CASSETTE CAR STEREO PLAYER

MODEL CS-204

SUPPLEMENT DATA

No. 272-1

CIRCUIT DIAGRAM

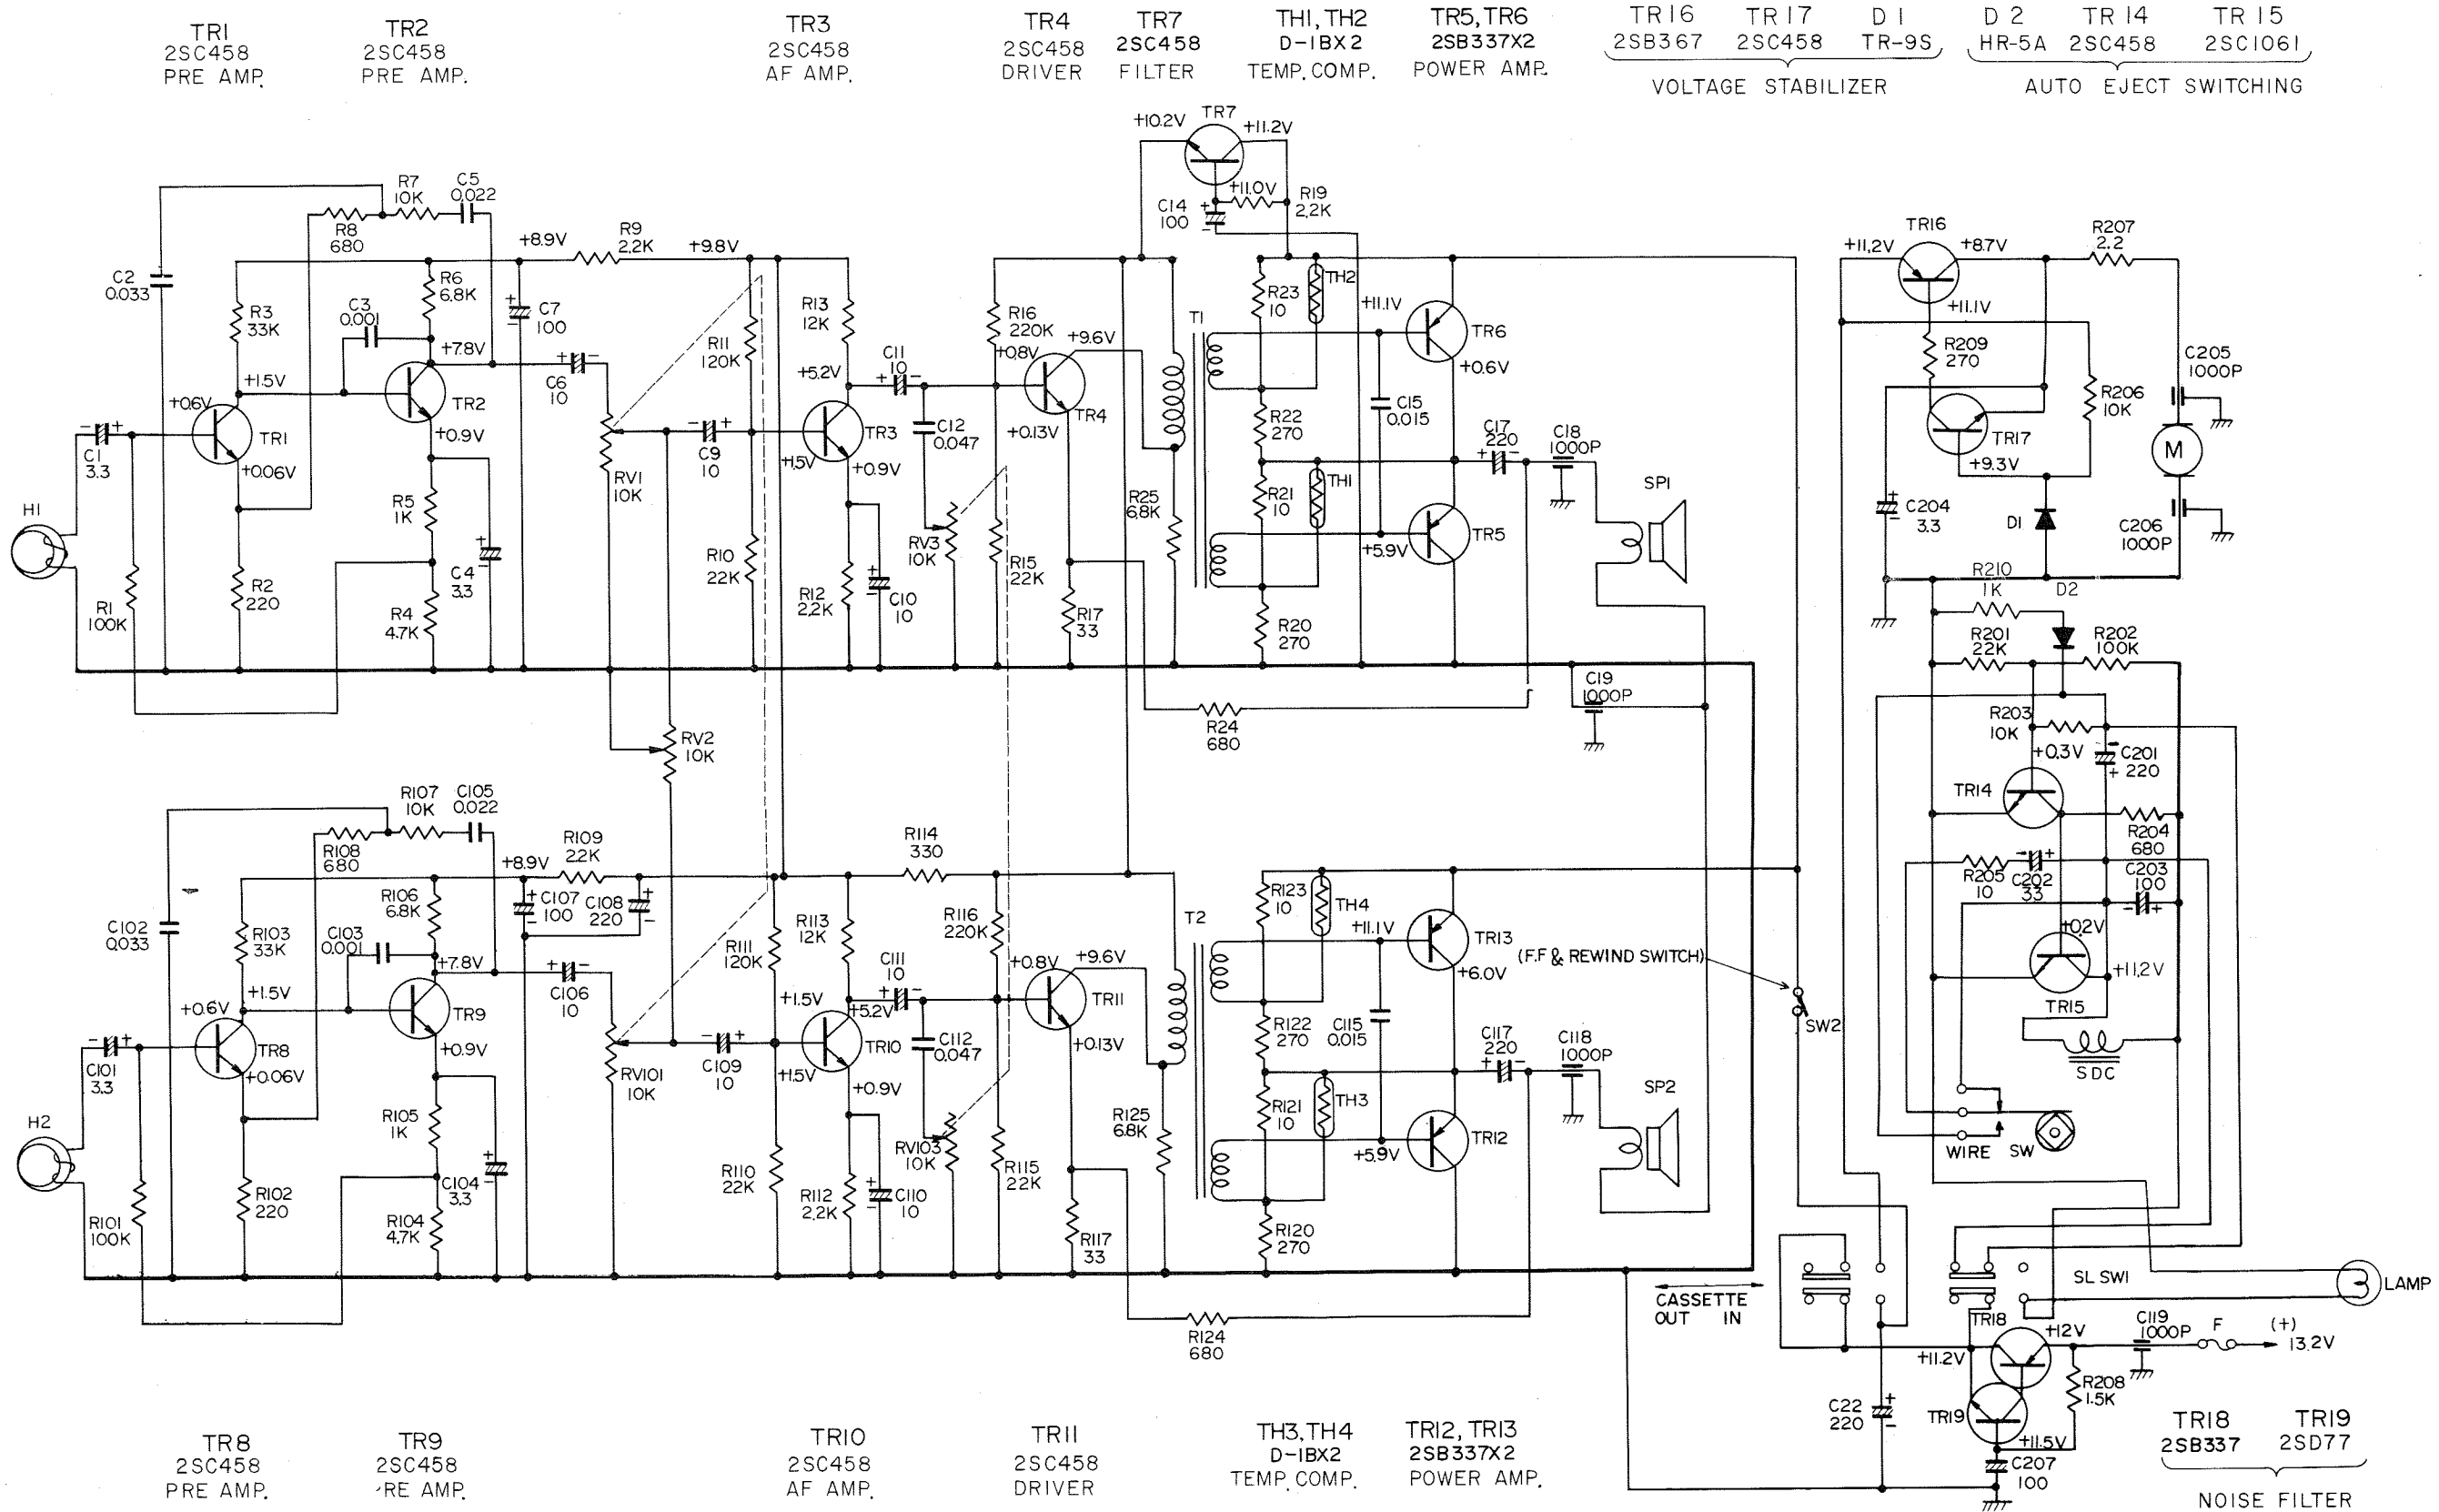
Model CS-204 SERVICE MANUAL (No. 272) to be changed to following on the list.

Delete (is now)				Correct (to be changed to)			
TRANSISTORS				TRANSISTORS			
Symbol No.	Stock No.	Description		Symbol No.	Stock No.	Description	
TR 1	0573066		2SC281(C)	TR 1	5320023		2SC458(C)
TR 2	0573066	Same as TR1		TR 2	5320023	Same as TR1	
TR 3	0573469		2SC281(C)	TR 3	0573481		2SC458(C)
TR 4	0573469	Same as TR3		TR 4	0573481	Same as TR3	
TR 8	0573066	Same as TR1		TR 8	5320023	Same as TR1	
TR 9	0573066	Same as TR1		TR 9	5320023	Same as TR1	
TR 10	0573469	Same as TR3		TR 10	0573481	Same as TR3	
TR 11	0573469	Same as TR3		TR 11	0573481	Same as TR3	
TR 14	0573119		2SB77(C)	TR 14	0573480		2SC458(B)
TR 15	0573022		2SB370(A)	TR 15	5320433		2SC1061(C)
TR 19	0573469		2SC281(C)	TR 19	5320361		2SD77(AB)
